Product Change Notification

Date Issued :	June 09, 2023	PCN Number :	513747
Reason for Change :	Change Supplier		
Description of Change :	This notification is to inform you about addition of new Supplier or Sub Supplier impacting the part(s) as per attached list. No changes will be made to product as part of this change		
Assessment of Change :	Supplier Qualification Test Report/s		
Planned Implementation Date :	December 25, 2023		
Sample Availability Date:	June 15, 2023		
Internal Molex Qualification Date :	July 01, 2023		
Last date to request Samples by Customer :	October 31, 2023		
Traceability Code Markings / Date :	Date code

Product Picture

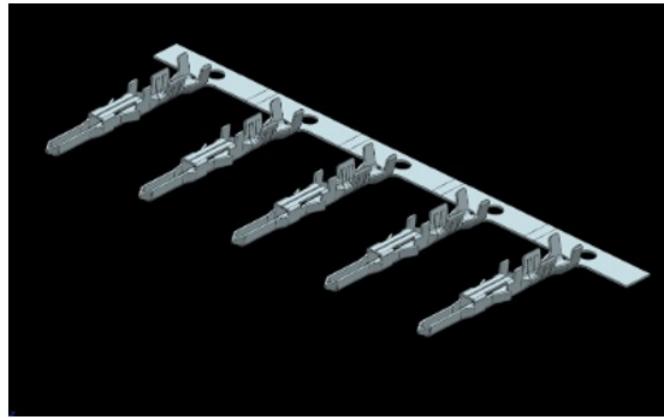
- Because current vendor has capacity shortage issue, we must qualify second source to keep production running. Metal alloys are not changed.
- Product Impact
 - no impact to fit, form or function
- ✓ Before: C26000 PL 0.203 X 25.00(H06)
- ✓ After: C26000 PL 0.203 X 25.00(H06)
- ✓ Product will be fully qualified before it is shipped. Qualification reports will be available after below listed date.
